**KNOWLEDGE BASE**Article Type: **Instructions****Control Chief Radio Modems,
used on PTS, Trac-a-Rac, and
Paco Crawler****Description:**

Instructions on converting from old series 2400 to new series 2410 Control Chief Radio Modem.

Instructions for converting the Old series 2400 to new series 2410

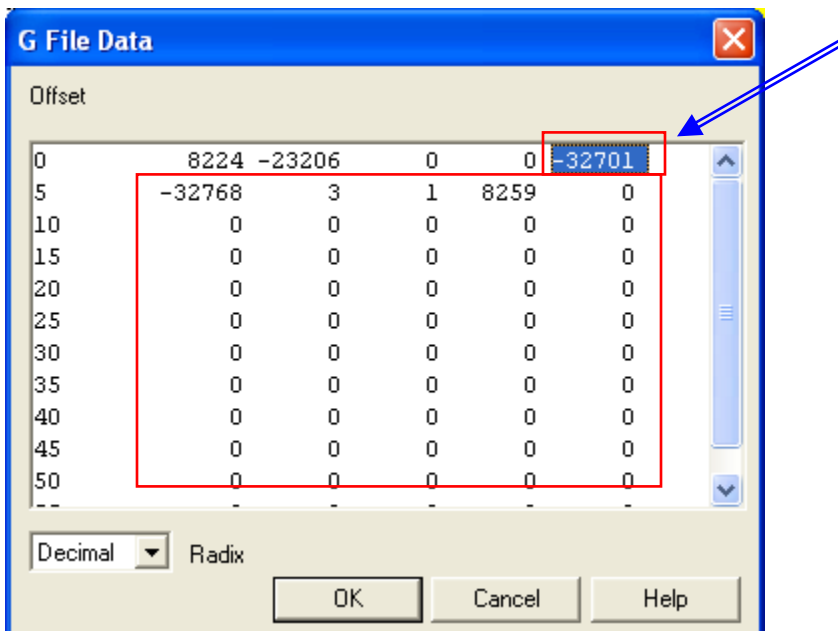
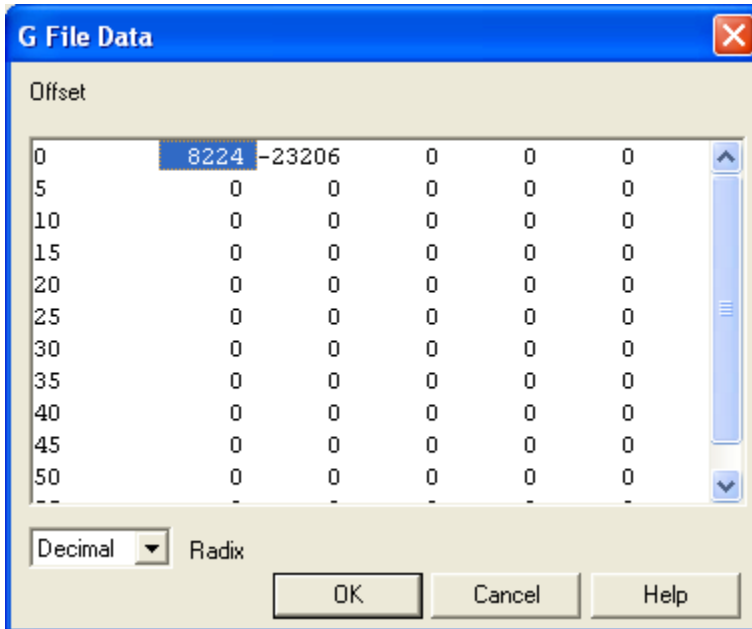
ISSUE: Replacement radio cards fault when installed in the rack.

Due to changes made in the newest revision of the Control Chief Radio Modems, the G file must be changed in the RSLogix software. This can be done by editing the IO configuration for the slot that the radio modem is installed in. The required steps to complete this procedure are outlined in this document.

4. The values in the first two columns of row 0 MUST match the values of the G File of the other car. **Change the remaining values to 0.**

Original G File:

Updated G File:
